Randwick Campus Redevelopment

Traffic and Transport Assessment
Response to Submissions - Sydney
Children's Hospital Stage 1/
Children's Comprehensive Cancer
Centre (SSD-10831778)

Final | 29 September 2021

Drawing Title
Turning Paths
Vehicle access to SCH1/CCCC
Logistics Area

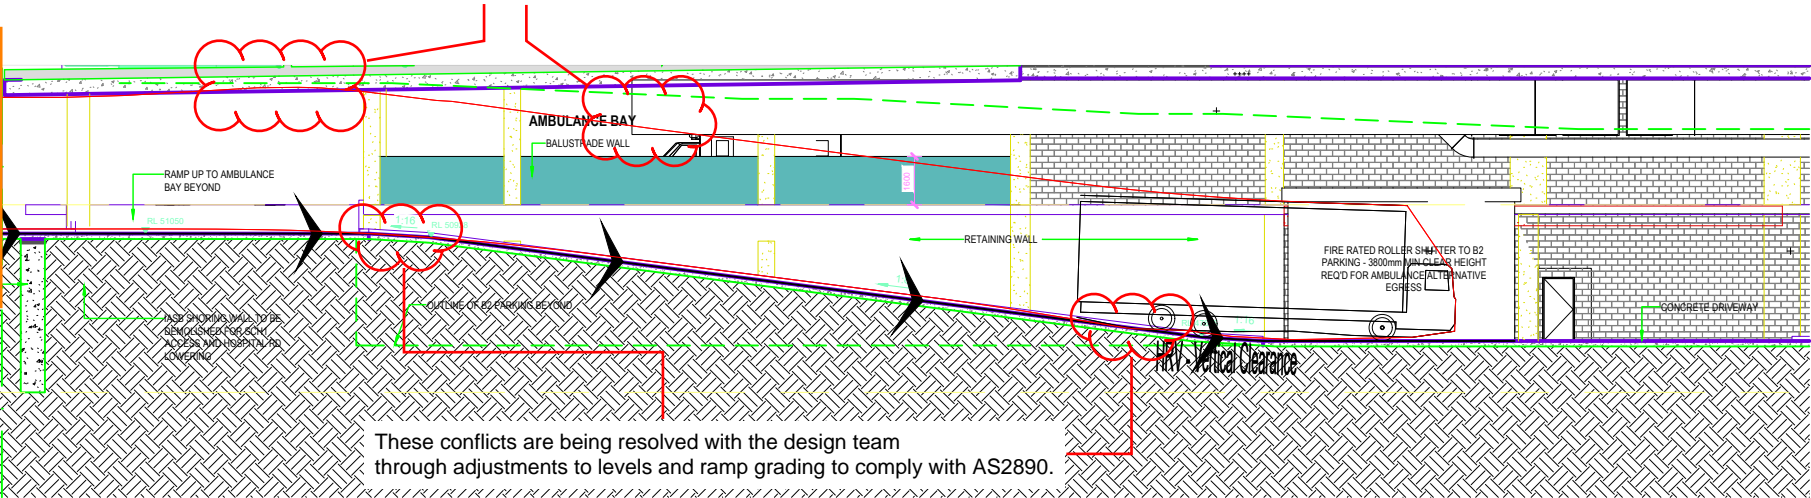
These conflicts are being resolved as part of design development with the design team through coordination with relevant services and adjustments to structural elements.

| Job No 257913-00 | Drawing No SKT004 | Issue A |

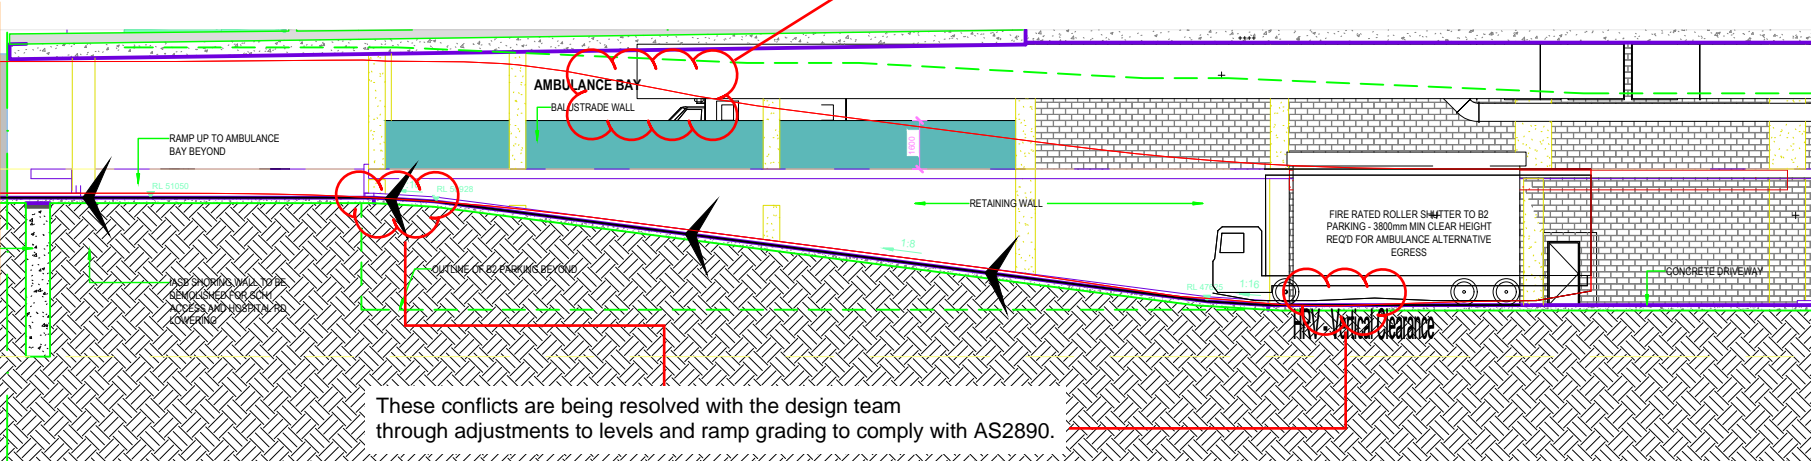
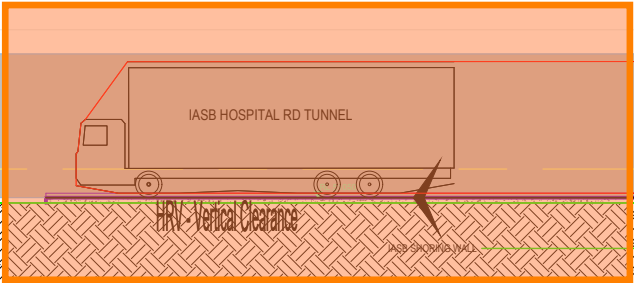
It should also be noted that the assessed HRV has a height of 4.3m, with the head clearance conflicts associated with a headroom clearance of 4.5m in line with AS2890.

These conflicts are being resolved with the design team through adjustments to levels and ramp grading to comply with AS2890.

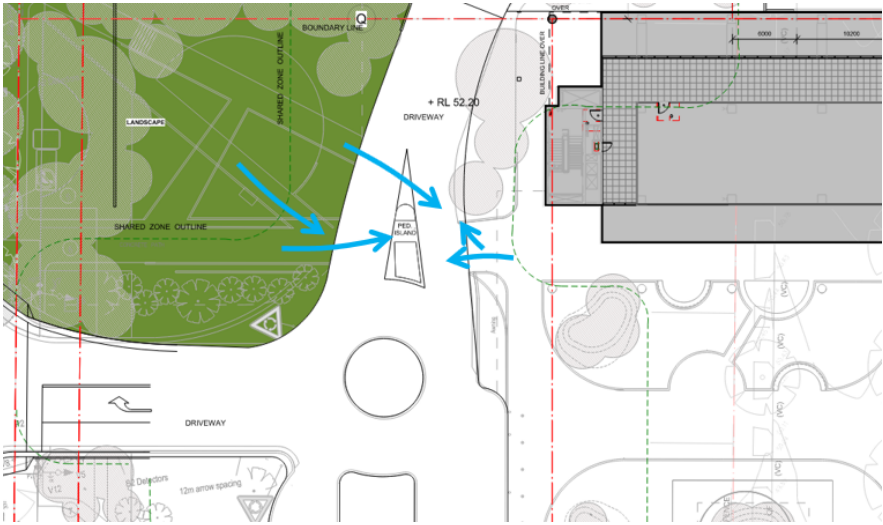
| Item (CAR Reference) | Safety Hazard Findings | Frequency | Severity | Level of Risk | Project Team Response |
|--|---|------------|----------|---------------|--|
| 1. Carpark ramp access <i>Road furniture, barrier protections.</i> | <p>It is not clear to the audit team a proposed barrier or fence to prevent pedestrians to continue to the carpark ramp access.</p> <p>There is a risk that pedestrian could fall to the bottom of the ramp</p>  | Occasional | Serious | HIGH | A barrier system of suitable height will be coordinated with BLP and Aspect so that pedestrian safety and falls from height is maintained in the next design drawings. |

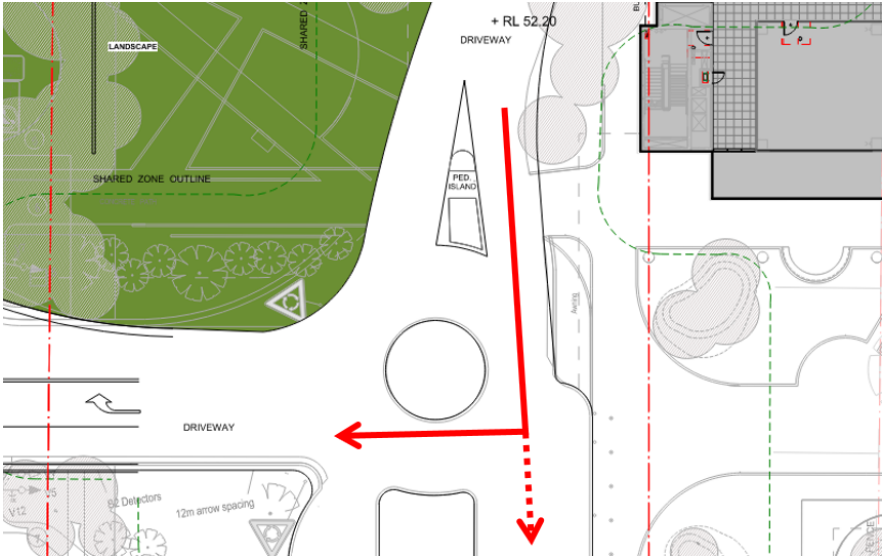
| Item (CAR Reference) | Safety Hazard Findings | Frequency | Severity | Level of Risk | Project Team Response |
|---|--|------------|----------|---------------|---|
| 2. Carpark ramp access <i>Traffic circulation</i> | <p>It is not clear the control priority at the access / egress of future HTH building located halfway on the ramp access.</p> <p>Vehicles entering or exiting the HTH building may not be able to see vehicles exiting the carpark increasing the risk of collisions.</p> <p>Vehicles from the carpark may have some difficulties exiting the ramp if they have to give way to vehicles from HTH building.</p>  | Improbable | Serious | MEDIUM | The basement ramp to B1 will have priority with HTH giving way. This will be coordinated with the Civil Engineer when they develop a detailed set of traffic signs and lines drawing. |

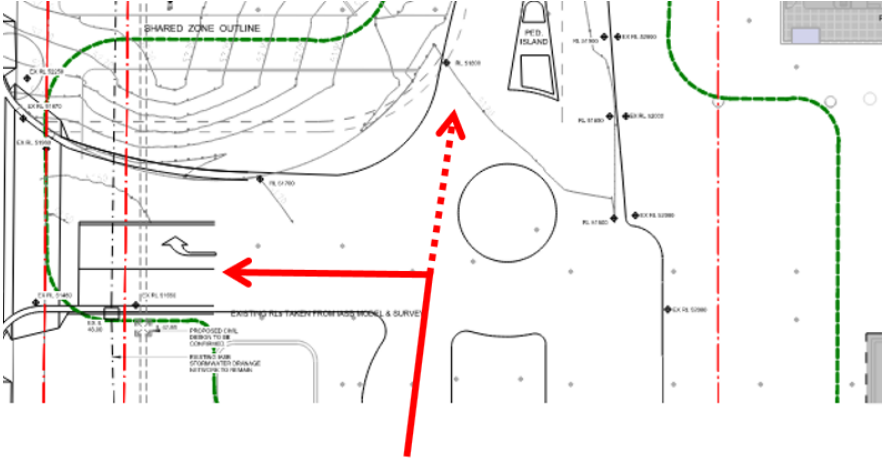
| Item (CAR Reference) | Safety Hazard Findings | Frequency | Severity | Level of Risk | Project Team Response |
|--|--|------------|----------|---------------|---|
| <div>3. Carpark ramp access</div> <div>Traffic circulation</div> | <div>It is not clear if the traffic circulation adjacent to the pick-up and drop-off area is one way one only. Intersection control priorities are not provided to the audit team.</div> <div>Vehicles exiting from the carpark or HTH building may conflict with vehicles entering the pick-up / drop-off area. This could increase the risk of front and side collisions.</div> <div></div> | Improbable | Serious | MEDIUM | <div>The drop off will have priority with basement ramp to B1 and HTH giving way. This will be coordinated with the Civil Engineer when they develop a detailed set of traffic signs and lines drawing.</div> |

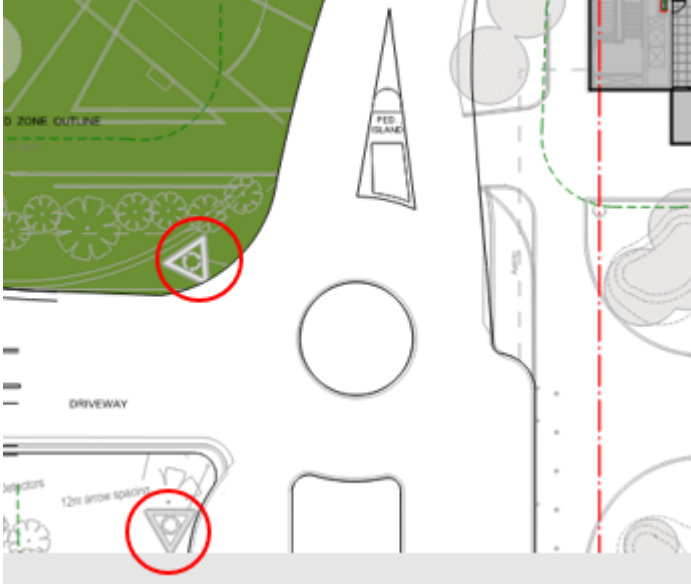
| Item (CAR Reference) | Safety Hazard Findings | Frequency | Severity | Level of Risk | Project Team Response |
|---|---|------------|----------|---------------|---|
| <div>5. Carpark ramp access</div> <div>Road furniture, barrier protection</div> | <div>There are not details provided to identify a suitable barrier system along the ramp access and edge of the pick-up and drop-off area.</div> <div>There is a risk of vehicles falling on the step landscape area and ramp to the lower carpark.</div> <div></div> | Occasional | Serious | HIGH | A barrier of suitable design and height will be coordinated with BLP and Aspect so that both vehicle and pedestrian safety is maintained in the next design drawings. |

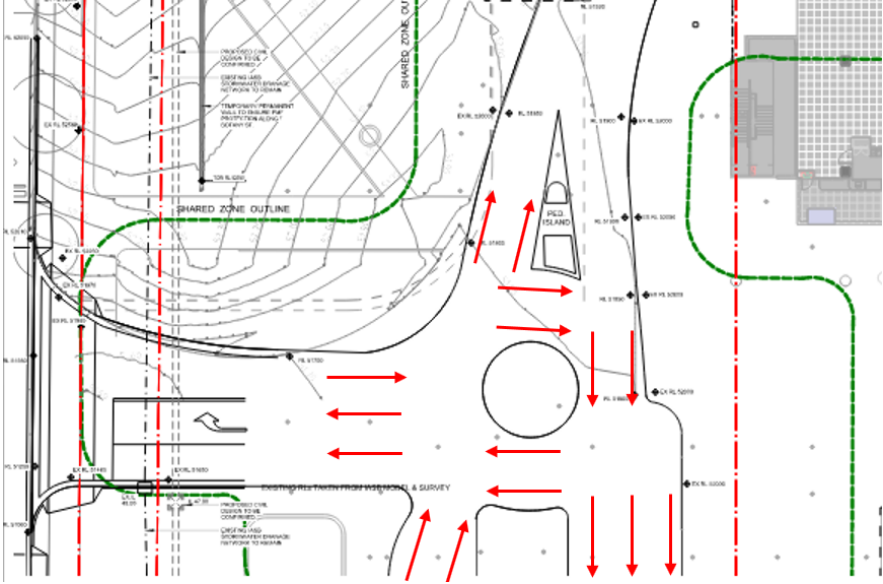
| Item (CAR Reference) | Safety Hazard Findings | Frequency | Severity | Level of Risk | Project Team Response |
|--|--|------------|----------|---------------|---|
| 6. Roundabout main access <i>Pedestrian connectivity</i> | <p>The proposed open space adjacent to the main access creates some desired lines for pedestrians to and from the IASB building that are not fully covered by the proposed pedestrian refuge. There is a risk that pedestrian may not use the provided refuge increasing the risk of being hit by vehicle.</p>  | Improbable | Serious | MEDIUM | <p>This is considered part of the IASB scope.</p> <p>The landscape plan will be coordinated with Lendlease and Aspect so that pedestrian paths are perpendicular to the road and in line with the crossing as required.</p> |

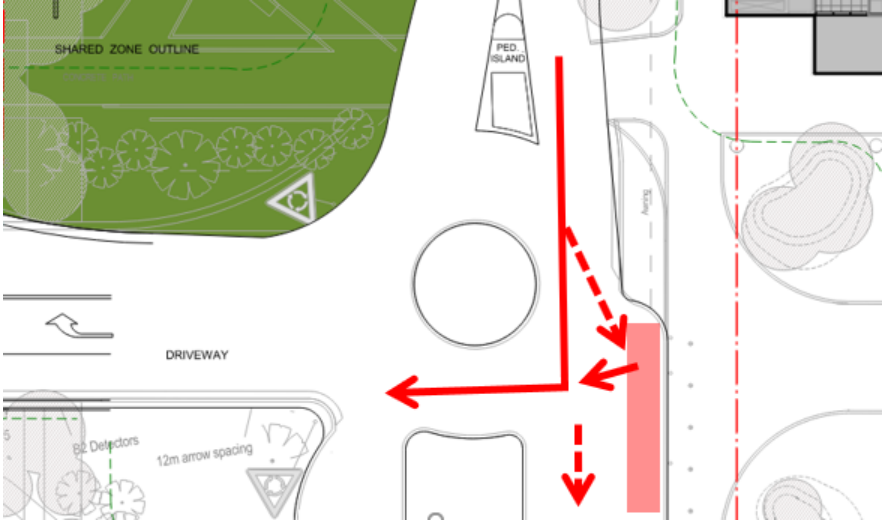
| Item (CAR Reference) | Safety Hazard Findings | Frequency | Severity | Level of Risk | Project Team Response |
|--|--|------------|----------|---------------|--|
| 7. Roundabout main access Road alignment | <p>There is no geometric deflection through the proposed roundabout for vehicles approaching the roundabout from the northern site.</p> <p>Vehicles may not reduce the speed as expected or may have to reduce their speed abruptly when approaching the roundabout before turning right onto the driveway exit. This could increase the risk of side and rear end collisions with vehicles approaching the roundabout from the other two approaches.</p> <p>In addition, vehicles could continue straight south missing the roundabout defeating the purpose of the roundabout.</p>  | Occasional | Minor | MEDIUM | <p>This is considered part of the IASB scope.</p> <p>The vehicles from the north will be turning right to exit and not travelling straight to the IASB drop-off from the SCH or HTH site.</p> <p>There will be appropriate TB (holding) lines on approach and C1 (continuous) lines around the roundabout to direct vehicles. This will be coordinated with Lendlease when they develop a detailed set of traffic signs and lines drawing.</p> |

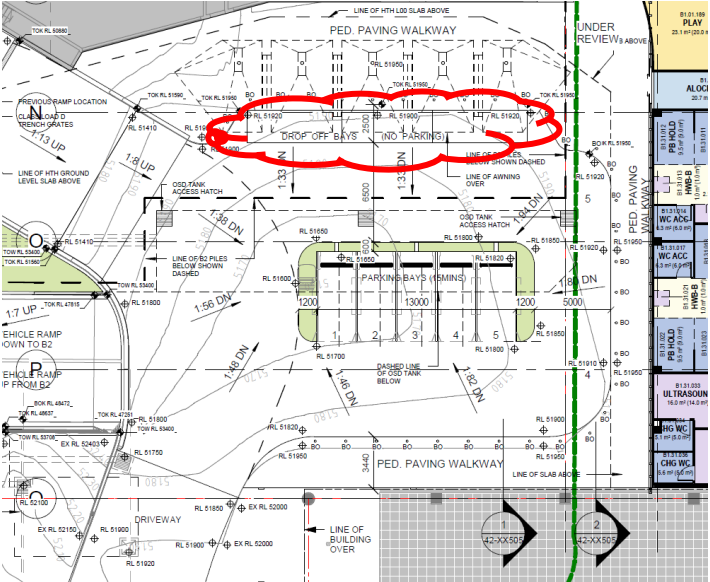
There is a sharp angle for vehicles approaching the pedestrian refuge from the northern site. There is no delineation provided for the traffic lanes.

There is a risk that vehicles may mount the pedestrian refuge island increasing the risk of hitting pedestrians.

There will be appropriate BB (centre) lines the roadway between the SCH drop-off and roundabout to delineate vehicles on the curve. This will be coordinated with Lendlease when they develop a detailed set of traffic signs and lines drawing.
